18 February 2026

Our Ref: 26-027

Re Submission to exhibition of SSD-85974227 at 9-17 Balfour Street, Lindfield

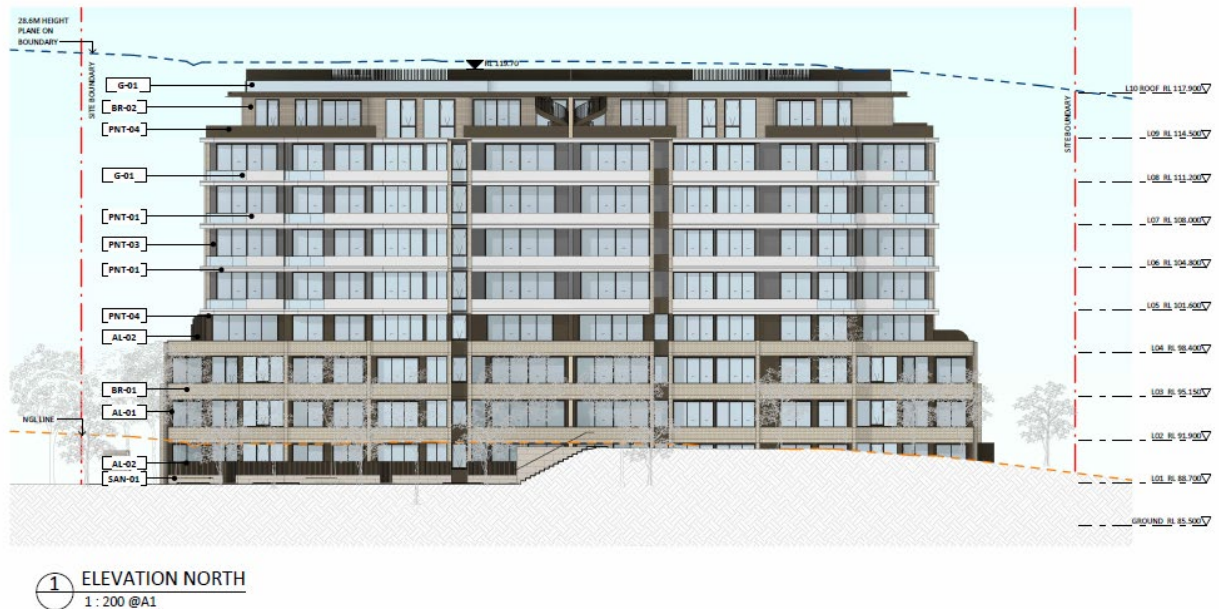
A key element in urban design, as reflected in the ADG, is a step down in building height at the boundary between two density zones. In this regard, the two sites in Balfour Street on which current SSD proposals are "saved" should be considered to be in a density zone different to that in which our client's property is located. The proposed development does not comply with Objective 3F-1 and associated design criteria and design guidance which states in part:

Apartment buildings should have an increased separation distance of 3m (in addition to the requirements set out in design criteria 1) when adjacent to a different zone that permits lower density residential development to provide for a transition in scale and increased landscaping (figure 3F.5)

A development that complies with the ADG would have the rear boundary setback above 4 storeys increased by at least 3 metres to 12 metres. The transitional requirements of the ADG should be observed.

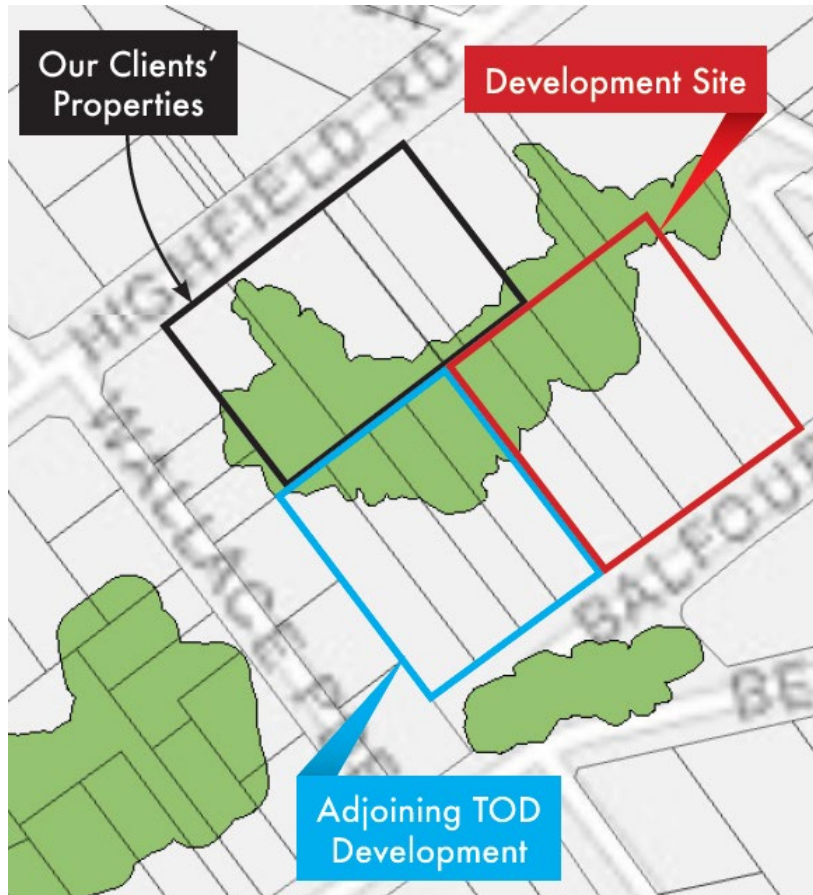
There is the potential for extensive and unacceptable overlooking resulting in a loss of privacy to the rear windows and private open spaces of our clients' properties from the north west facing balconies and living rooms in the proposed development. There is insufficient setback for retention of trees and for substantial additional planting that might reduce such impacts.

The following extract from the DA plans, which is the north elevation facing the rear of our client's property clearly illustrates this issue:
